URBAN DESIGN ISSUES REPORT : 24 - 36 Langston Place, EPPING (Council DA/237/2017)

This Report has been prepared by Richard Thorp of Thorparchitecture Pty Ltd for Sydney Central City Planning Panel *

Report INTENT (panel reference 2017SWC048)

Fig 5. Comparison of original tower footprint (red line) vs revised tower footprint (green line). Light shaded area indicates increased separation, light green shaded area indicates less setback from the street.

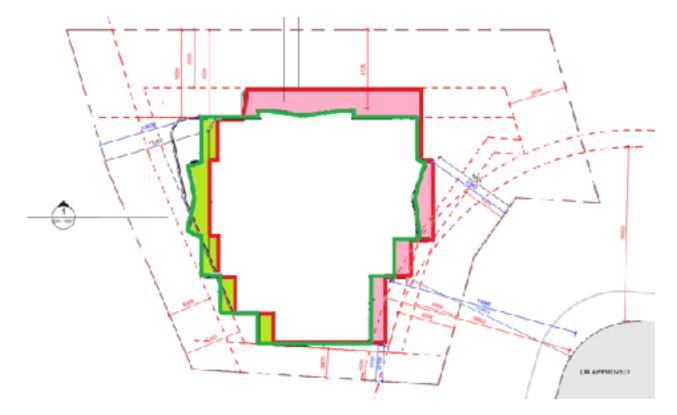
Reviewing the revision to the Tower footprint reveals that there are improved outcomes to both separation and privacy between the towers.

A summary of the separation dimensions contained in Fig 5 (above) including ADG recommendations follows:

Upper Level Tower separation to:	ADG	Original DA	Revised DA
North (boundary)	12m	6m (50%)	9m (75%)
Approved Tower 2 @ 12 -22 Langston Place	24m	18m (75%)	19.8m (83%)
South (boundary)	12m	3m (25%)	3m (25%)

The Council's Table (above) outlining the *ADG recommended, originally proposed, and currently proposed separation* dimensions demonstrate acceptable improvements as a result of the Design Revisions and should be supported.

Of the above 3 'separation issues', the first two seem reasonable and acceptable given the constrained nature of the site. They are also supported and "considered acceptable" by Council's Urban Design Team, City Architect and DEAP.

The separation to the South boundary of only 3m compared to ADG 12m should be considered with regard to the Site Plan, which shows that beyond the South boundary it is open space rather than a built element that abuts the site. Tower 3 is a considerable distance away and does not present as an issue. This 3m separation to boundary is also supported by Council Urban Design Team, City Architect and DEAP.

OUTCOME : In summary, the increase in building separation is considered a positive revision to the development.

CHECK SHADOW COMPARISON

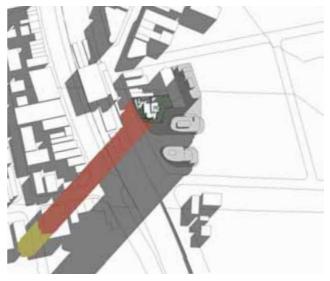
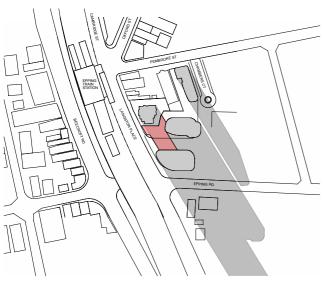
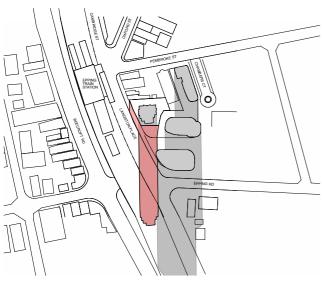
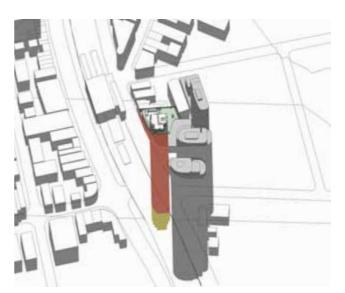
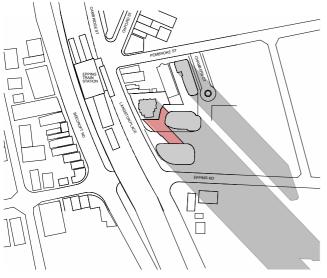
The following 3 pages show side by side comparisons of the Shadow Diagrams for the site as submitted by the applicant, and used in the Council assessment Report, with <u>new</u> Shadow Diagrams produced independently by Thorparchitecture for this report.

That both sets of Diagrams are almost identical offer sufficient evidence to state that the 'submitted shadow diagrams' are accurate and appropriate for use in Council undertaking the assessment.
